## MONTEREY COUNTY PLANNING COMMISSION

<b>Meeting:</b> February 11, 2015	<b>Time:</b> 10:30 AM	<b>Agenda Item No.:</b> 6
<b>Project Description:</b> Continued from December 10, 2014, and January 14, 2015. Consider a Combined Development Permit consisting of: 1) a Coastal Development Permit to allow development on slopes exceeding 30 percent (for the construction of turn-out areas on the existing access road); 2) a Coastal Development Permit to allow development within 100 feet of environmentally sensitive habitat; 3) a Coastal Administrative Permit and Design Approval to allow the construction of a 57-space public parking area and improvements to an existing access road; and associated grading.		
<b>Project Location:</b> Palo Corona Regional Park, east of Highway 1 between Ribera and Oliver Roads		<b>APN:</b> 243-081-008-000
<b>Planning File Number:</b> PLN130417		<b>Owner/Applicant:</b> Monterey Peninsula Regional Park District (MPRPD)

PALO CORONA REGIONAL PARK  
CALIFORNIA  
PROPOSED PARKING LOT - PLANNING SUBMITTAL  
PRELIMINARY GRADING PLAN - ROAD

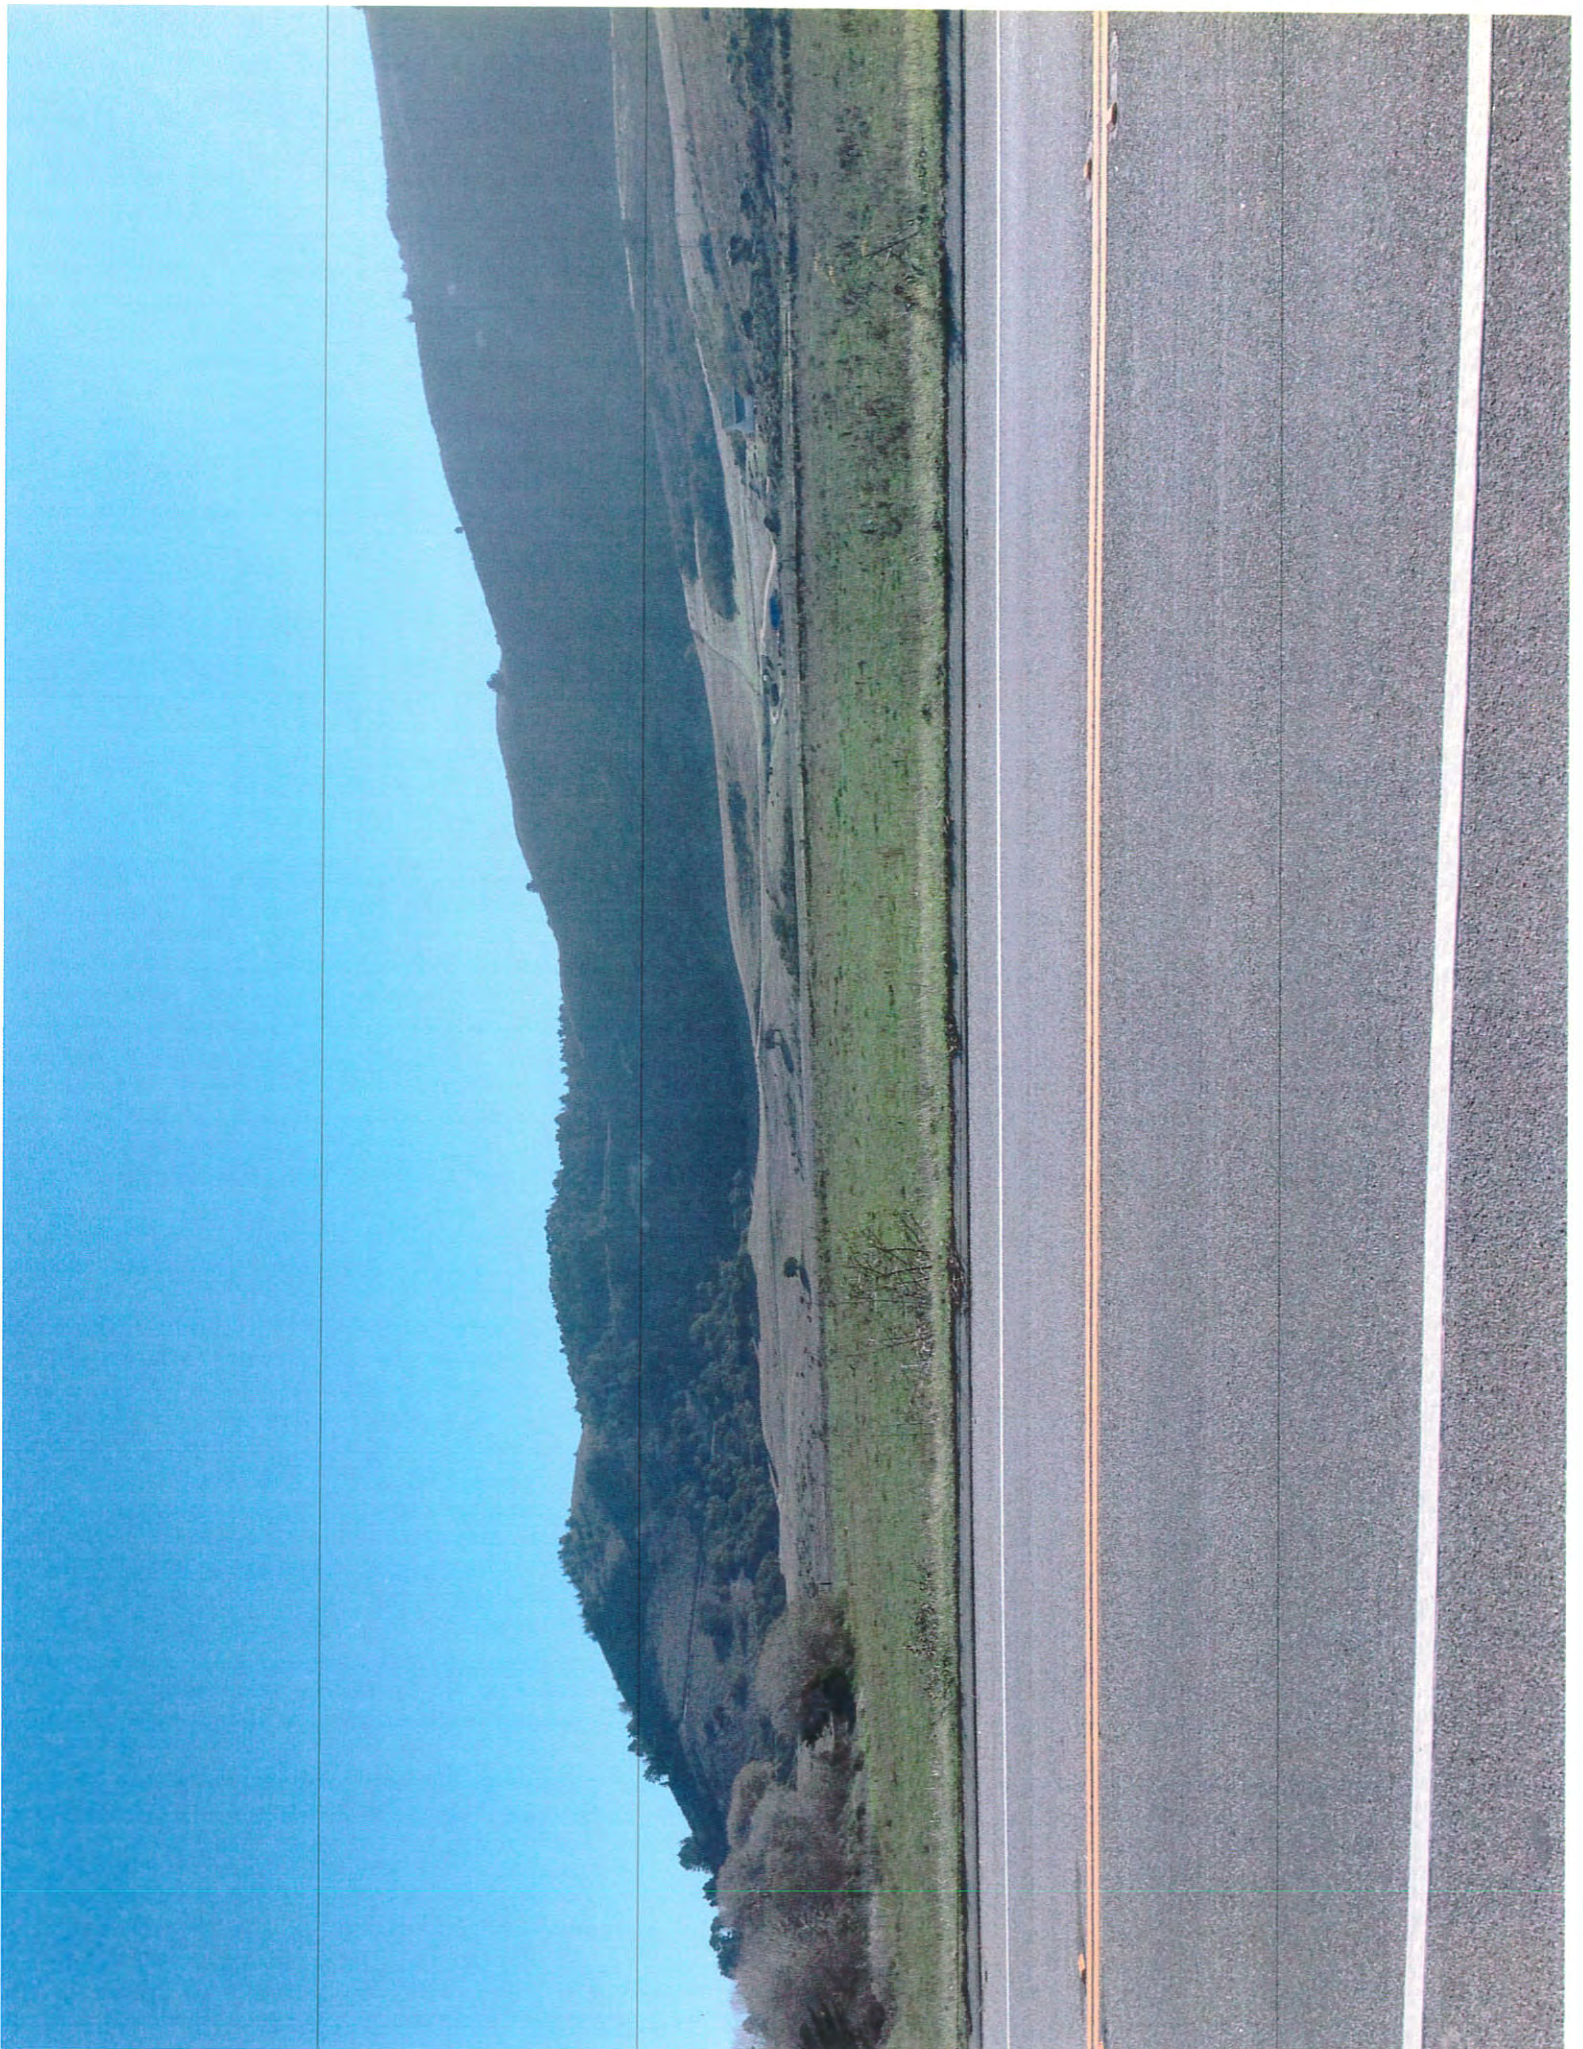
The proposed parking lot area is clearly in the public viewshed, not only from Inspiration Point, but from Highway 1, as well.

Please include this e-mail and photo in the Planning Commission's package.

**PALO CORONA RANCH  
 INTERIM WIDENING &  
 LEFT TURN CHANNELIZATION**

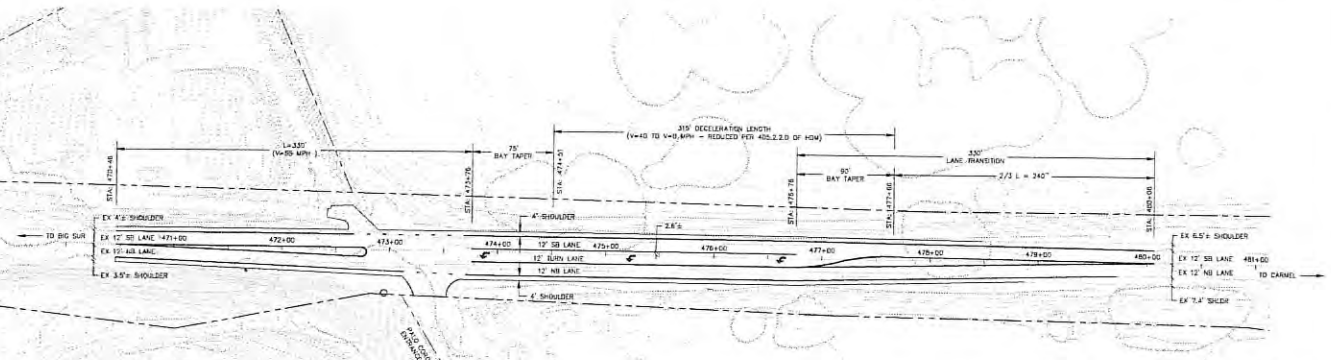
The standard approach taper (Figure 405.2A) for the proposed southbound left-turn lane, based on a design speed of 55 mph and assuming the proposed left-turn lane would be 12 ft. wide, is 660 ft. The minimum required approach taper for urban areas where widening of both sides of the road is proposed (Figure 405.2C) is equal to half the standard approach taper, or 330 ft. based on a design speed of 55 mph and a 12-ft. left-turn lane.

The improvements plan shows the approach taper to be 300 ft. This length most likely was calculated using the equation from Figure 405.2C of the HDM, and assuming a left-turn lane width of approximately 10.9 ft.
